## **Amendments**

## Amendments to the Figures:

ton-ket No 138-006 Revised sheet 3

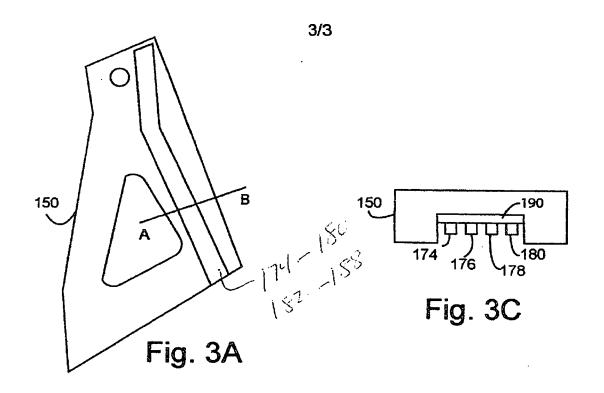
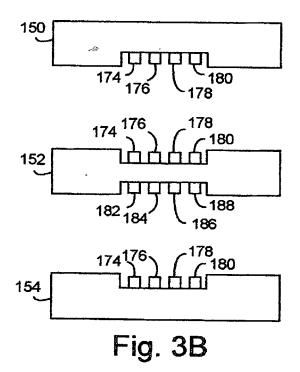
Figure 3A has been amended by red ink to indicate a first and a second pair of coplanor, parallel transmission paths 174-178 essentially parallel to the ground plane. The head arm 150 may further include a first and a second pair of coplanor, parallel transmission paths 174-178 essentially parallel to the ground plane.

Docket No: 139-006 new figure sheet

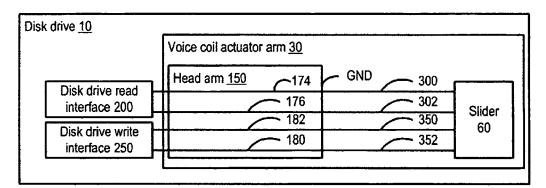
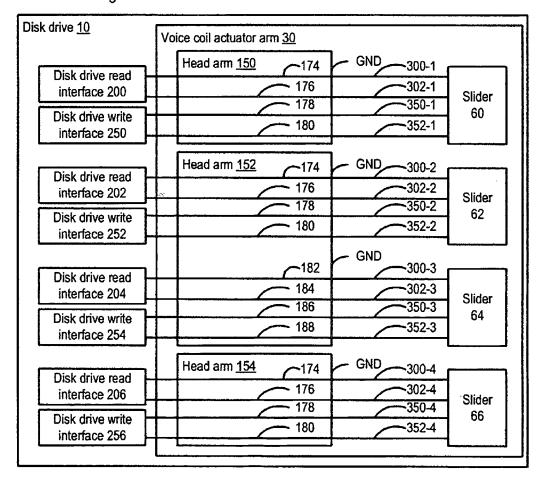
Figures 4A and 4B have been added to illustrate disk drive 10 include voice coil actuator arm 30 including at least one head arm 150 providing at ground plane for a first and a second pair of coplanor, parallel transmission paths 174-178 essentially parallel to the ground plane. The head arm 150 may further include a third and a fourth pair of coplanor, parallel transmission paths 184-188 essentially parallel to the ground plane.
